**Peer Review Record – re: CLOCA Draft Tier 1 Water Budget Report dated January 2009**

**Source Water Protection Draft Tier 1 Water Budget Peer Review Record – CLOSPA, January 2009**

**Subject: Central Lake Ontario Conservation Authority  
Review of Draft Tier 1 Water Budget Report for CLOSPA  
Final Report dated January 2009**

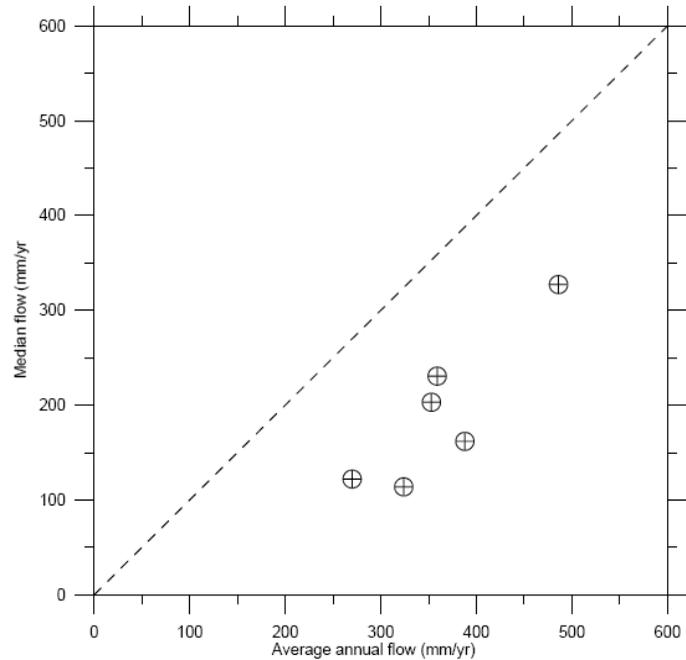
CN (SSPA) Page 35: In our opinion, it is difficult to assess the match between the observed and calculated groundwater levels referring only to Figures 34 and 35. We recommend that the reporting of the goodness-of-fit be supplemented with the following:

- Scatterplots comparing observed and calculated water levels in the Oak Ridges Aquifer Complex and the Thorncliffe Aquifer, with distinct symbols to indicate water level targets corresponding to high-reliability data (dedicated observation wells with survey control and boreholes logged by a professional geoscientist);
- Plots of the cumulative probability distribution of model residuals;
- Tables indicating observed and calculated water levels and model residuals, again with indications of high-reliability targets; and
- A listing of statistical measures of model goodness-of-fit.

This additional information can be included in an electronic supplement to the report.

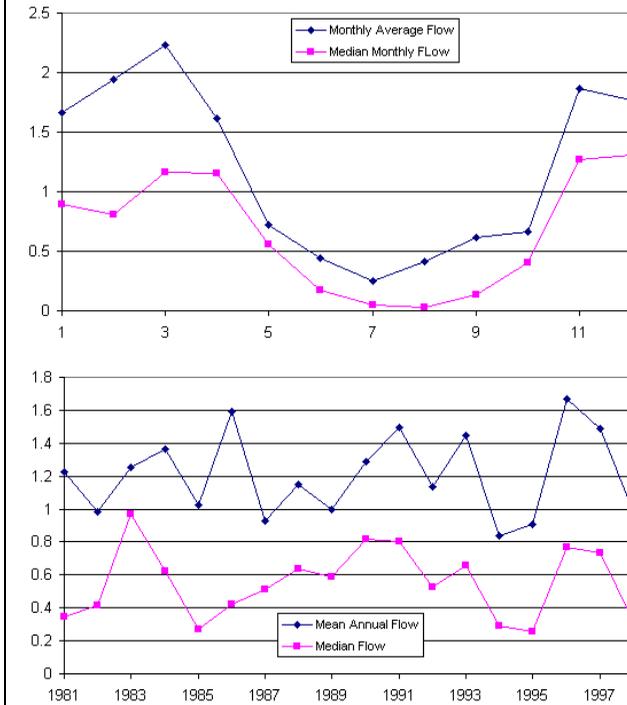
CN (SSPA) Page 36: In our opinion, it is difficult to check the calculations reported in Figure 38. We recommend that a table be added to indicate the values that are suggested in this figure.

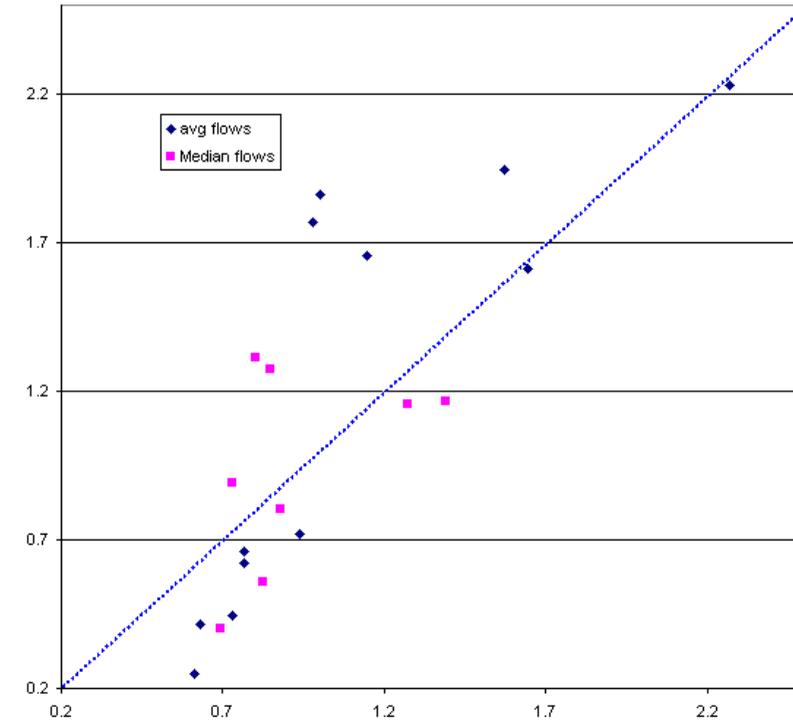
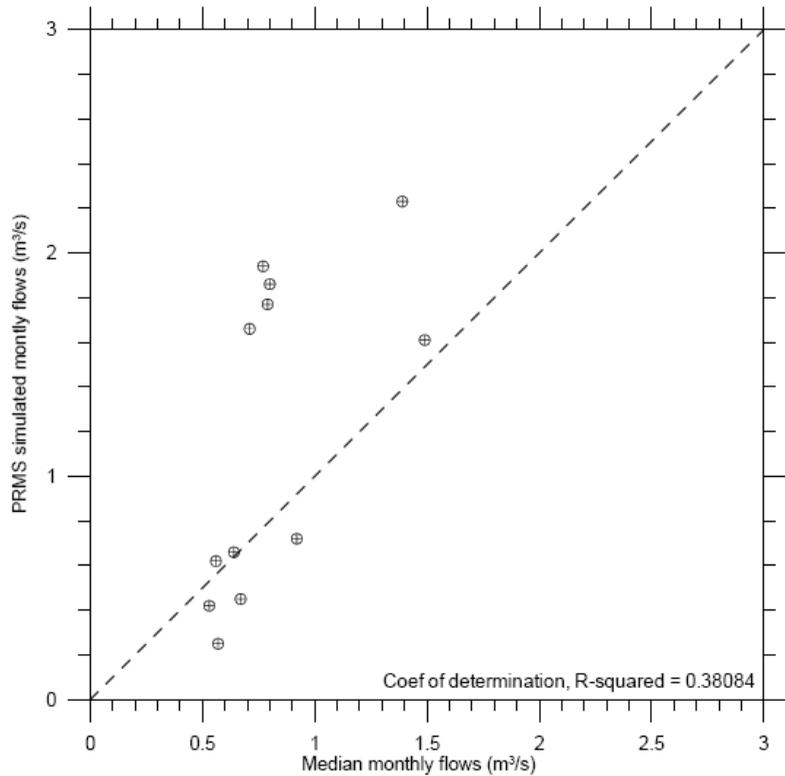
CN (SSPA) Page 36: The report indicates that median flows were compared with average flows. How are the average flows defined? The Period of Record (POR) median flows for the HYDAT stations listed on

Table 10 are plotted against the average annual flows listed on Table 7 in the figure below. There appears to be relatively little correlation between the two sets of values. Are we misinterpreting the comparison?

average flows showed a little more variation from month to month than the median flows (results for Oshawa Creek are shown below). Similarly, the mean annual average flows varied a little more from year to year than the median annual flows. It was only a minor point and it has been deleted.
